APPLICATION NO.	FILING DATE	FIRST NAMED INVENTOR	ATTORNEY DOCKET NO.	CONFIRMATION NO.
10/581,531	02/16/2007	Martin Stickel	2003P01010WOUS	3940

Office Action Summary	Application No. 10/581,531	Applicant(s) STICKEL, MARTIN	
	Examiner /Thor S. Campbell/	Art Unit 3742

DETAILED ACTION

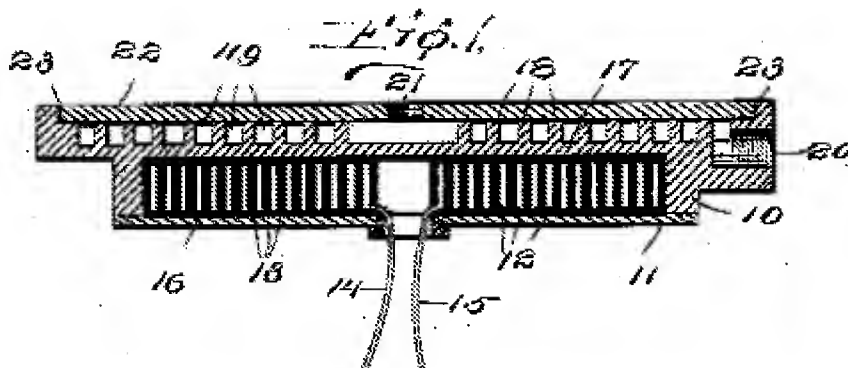
Claim 22, 46 are rejected under 35 U.S.C. 102(b) as being anticipated by Wade (US 941215).

Wade discloses:

22. A heating device for fluids, the heating device being adapted for mounting thereof in a continuous flow heater, the heating device comprising: at least one heating element 12 configured as an electric resistance heater; and at least one heat exchanging element 18 for the exchange of heat between the heating element and a fluid, the heat exchanging element 18 being connected in a heat-conducting manner to the heating element and the fluid so as to transfer the heat generated by the heating element to the fluid and the heat exchanging element forming an integral housing component 10 of a pressure-resistant and temperature-resistant continuous flow heater and having a substantially planar

central area (recess) on which the heating element is mounted.

46. The heating device according to claim 22, further comprising a connecting element 20 located at a periphery of the heating device, the connecting element being adapted to connect to a corresponding connecting feature of the continuous flow heater (not shown), wherein the connecting element does not cross a plane that intersects and is parallel to the central area.

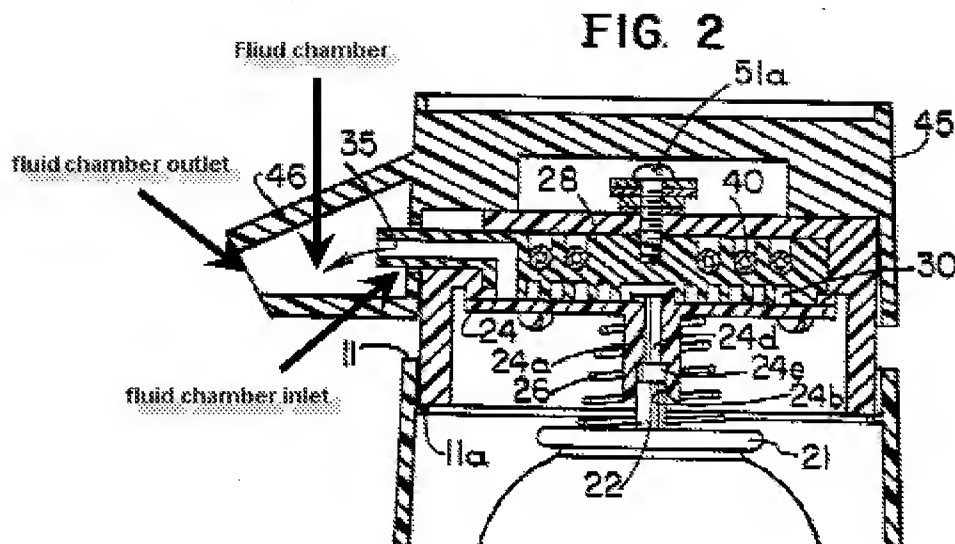
Claim 32, 39 are rejected under 35 U.S.C. 102(b) as being anticipated by Baum (US 3710985).

Baum discloses in reference to claim :

32. A continuous flow heater comprising: a heating device including: a heating element 40; and at least one heat exchanging element 28 for the exchange of heat between the heating element and a fluid, the heat exchanging element being connected in a direct heat-conducting manner to the heating element and the fluid so as to transfer the heat generated by the heating element to the fluid, and the heat exchanging element forming an integral housing component of a pressure-resistant and temperature-resistant continuous flow heater and having a substantially planar central area (spiral heating element 40 lies on a plane defined by the bottom of the groove 38) on which the heating element is mounted; and a molded part 45/46 separate from the heating device connected positively to the heating device (see Fig. 2) in a pressure-resistant and thermally stable manner to form a fluid chamber, the molded part having at least one inlet and at least one outlet.

39. A method for producing a continuous flow heater comprising the steps: a. producing a heating device including at least one heating element 40 configured as an electric resistance heater and at least one heat exchanging element 28 for the exchange of heat between the heating element and a fluid, the heat exchanging element being connected in a heat-conducting manner to the heating element and the fluid so as to transfer the heat generated by the heating element to the fluid and the heat exchanging element forming an integral housing component of a pressure-resistant and temperature-resistant continuous flow heater and having a substantially planar central area (spiral heating element 40 lies on a plane defined by the bottom of the groove 38) on which the heating element is mounted; b. producing a molded part 45/46 with at least one inlet and at least one outlet; and c. positively joining the heating device and the molded part so that the assembly is pressure-resistant and thermally stable.
